**STAFF RECOMMENDATION**  
**3801 Richland Avenue**  
**March 21, 2018**

**Application:** New construction - Addition  
**District:** Richland-West End Neighborhood Conservation Zoning Overlay  
**Council District:** 24  
**Map and Parcel Number:** 10409010400  
**Applicant:** Robert Thompson, Pfeffer Torode Architecture  
**Project Lead:** Paul Hoffman, paul.hoffman@nashville.gov

<p><b>Description of Project:</b> Side addition to contributing building.</p> <p><b>Recommendation Summary:</b> Staff recommends approval of the application, with the conditions:</p> <ol style="list-style-type: none"><li>1. Lap siding has a maximum exposure of five inches (5");</li><li>2. Shingle siding is installed in a straight-line course pattern with a maximum exposure of seven inches (7");</li><li>3. Staff approval of roof color, masonry, and windows;</li><li>4. HVAC and other utilities located on the rear façade, or on a side façade beyond the midpoint of the house.</li></ol> <p>With these conditions, staff finds that the application meets Sections II.B.1 and II.B.2 for New Construction and Additions in the Richland-West End Neighborhood Conservation Zoning Overlay.</p>	<p><b>Attachments</b> <b>A:

1 SITE PLAN  
SCALE 1/16" = 1'-0"

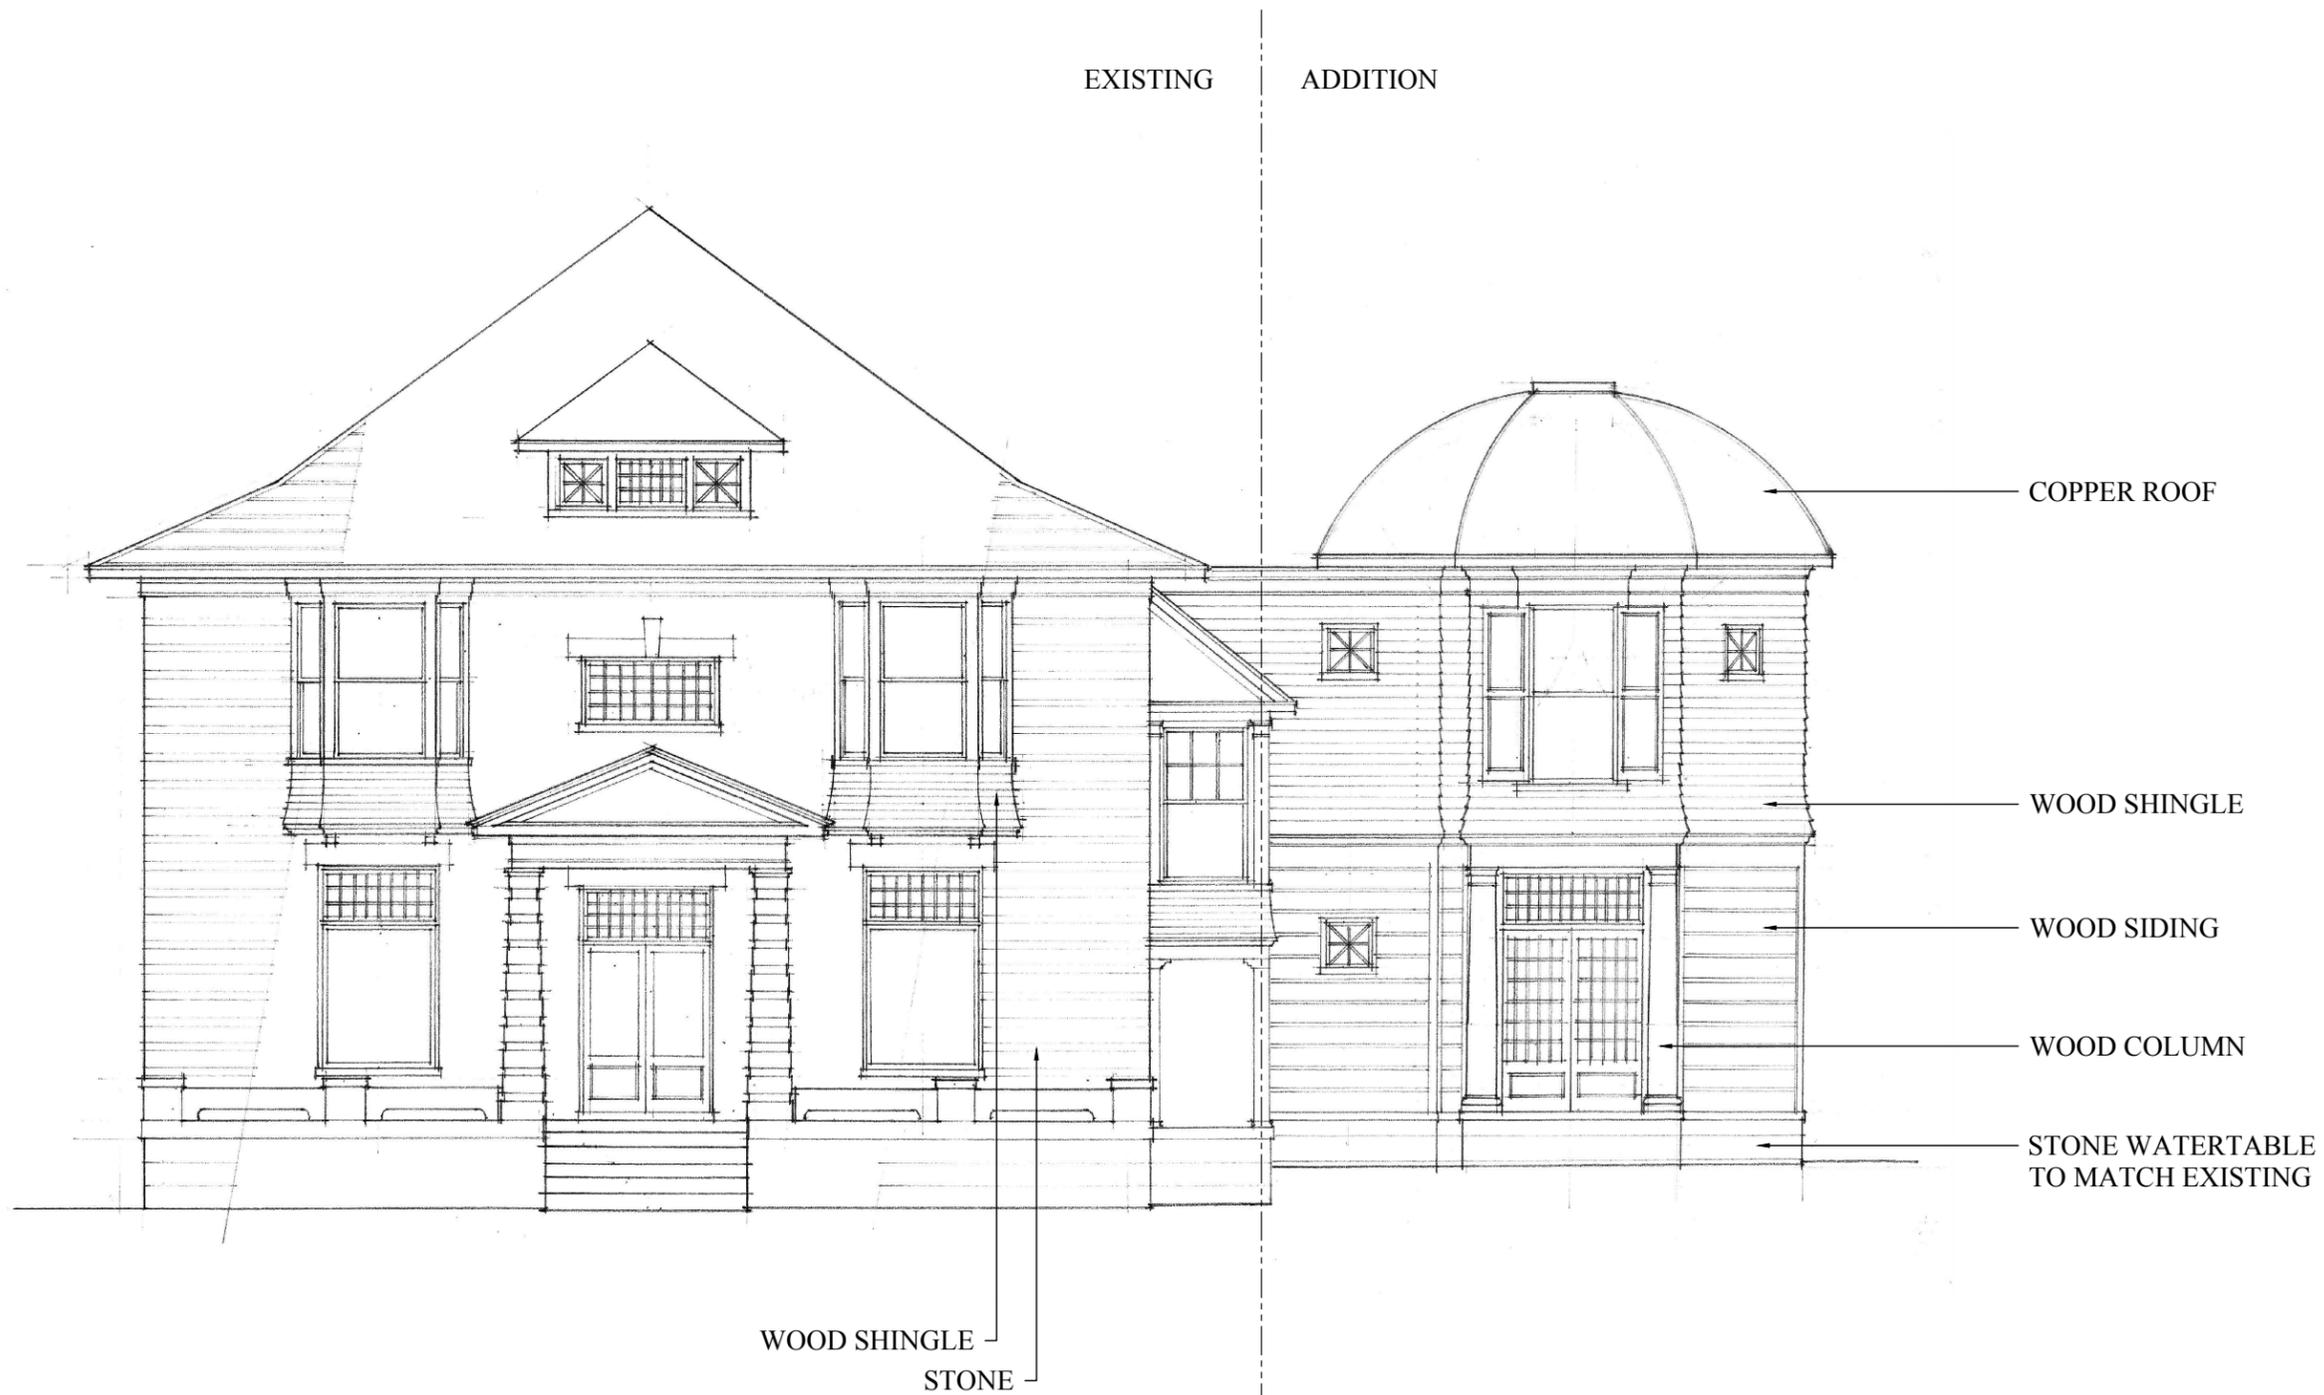
**Setback & Rhythm of Spacing:** The addition meets all base zoning setbacks; it will be ten feet, six inches (10'6") from the right side property line, and approximately one hundred and four feet (104') from the rear property line. The addition meets base setback requirements of five feet (5') on the sides and twenty feet (20') from the rear. The project meets section II.B.1.c of the design guidelines.

1 Front Elevation  
SCALE 1/8" = 1'-0"

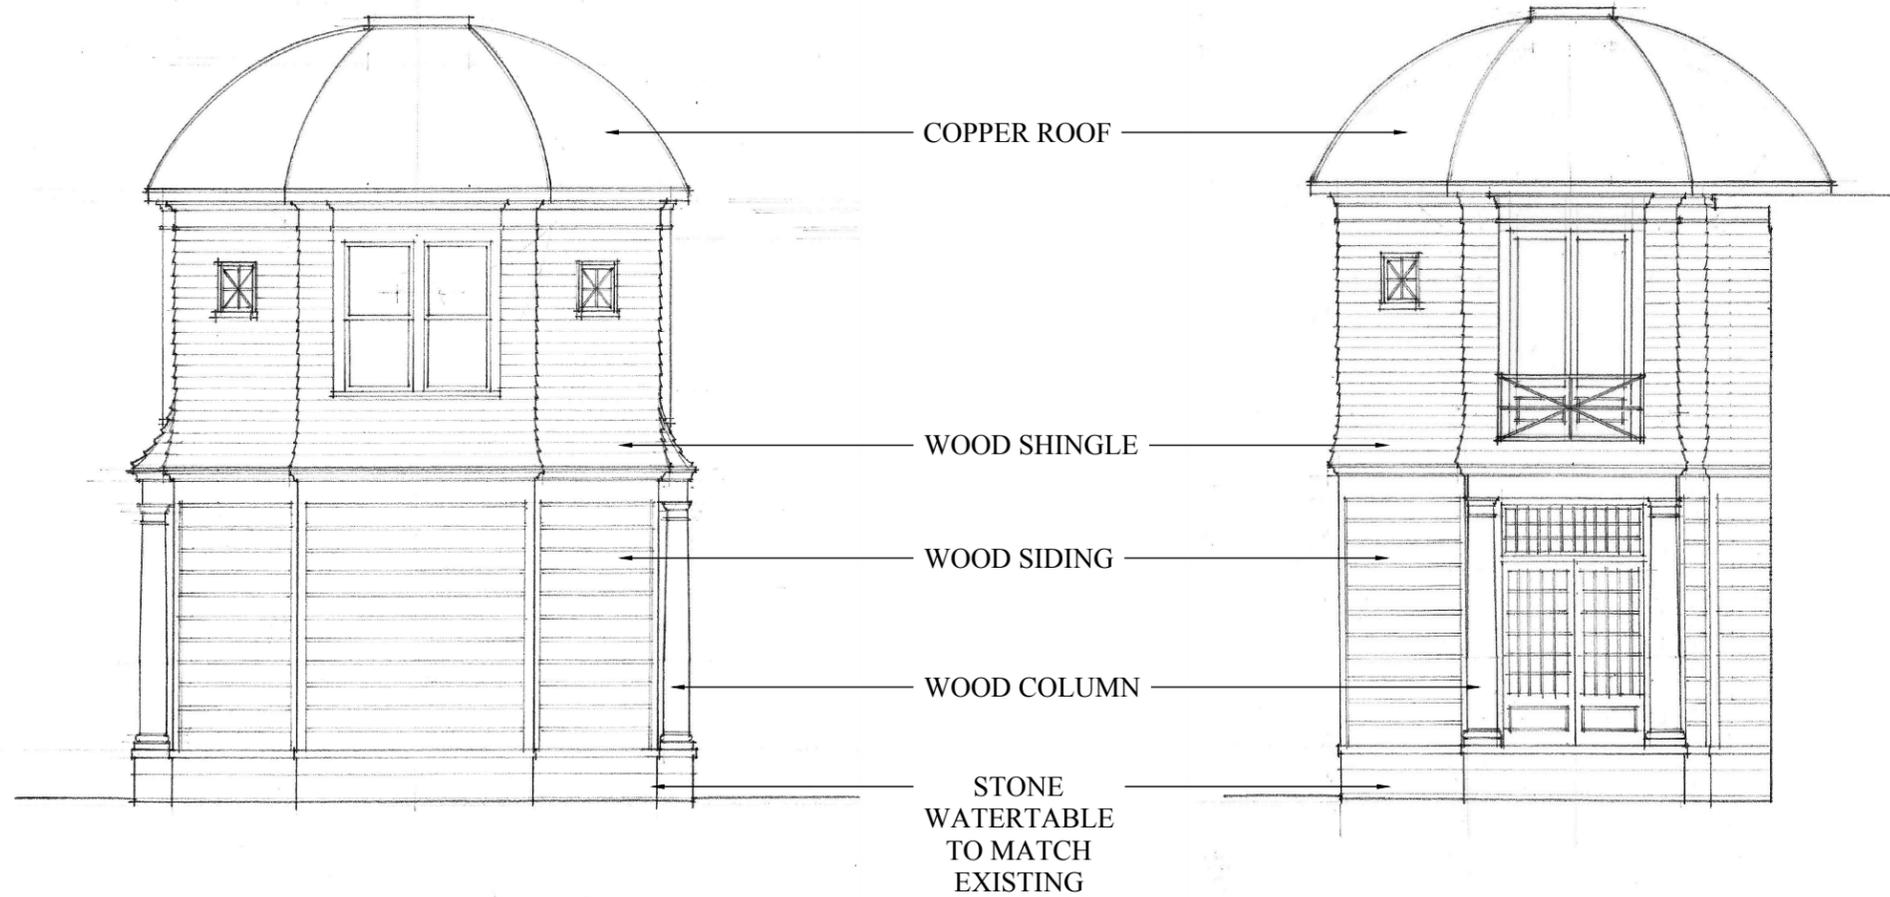
Height & Scale: The proposed addition measures twenty-eight feet (28') from the existing side wall, by twenty-one feet, ten inches (21'10"), for a footprint of approximately five hundred and ninety-nine square feet (599 sq. ft.) It is two stories with a maximum height of thirty-three feet (33'), compared to the ridge height of the house which is forty-four feet (44'). The foundation height will match that of the house. Staff finds that the massing of the proposed addition is subordinate to the historic building, and is appropriate in this case. The project meets sections II.B.1.a, II.B.1.b, and II.B.2.e.

Figure 2. Front elevation with proposed addition on right.

The proposed exposure of cladding materials was not indicated. The design guidelines for Richland-West End specify that the reveal for lap siding should not exceed five inches (5"), and the shingle siding should have a straight-line course pattern, and a maximum exposure of seven inches (7"). With the condition that Staff approve a stone sample, roofing color and windows, and that the lap siding and shingle siding meet these criteria for reveal, the project meets section II.B.1.d.

**Roof form:** The proposed domed roof is atypical of the district. However it is a roof form seen historically. The addition's roof is lower than that of the house, and the roof form helps differentiate the addition from the historic structure. For these reasons, Staff finds that the addition's roof form does not contrast greatly with the existing building. The project meets section II.B.1.e.

1. Lap siding have a maximum exposure of five inches (5");
2. Shingle siding exhibit a straight-line course pattern and have a maximum exposure of seven inches (7");
3. Staff approval of roof color, masonry, and windows;
4. HVAC and other utilities located on the rear façade, or on a side façade beyond the midpoint of the house.
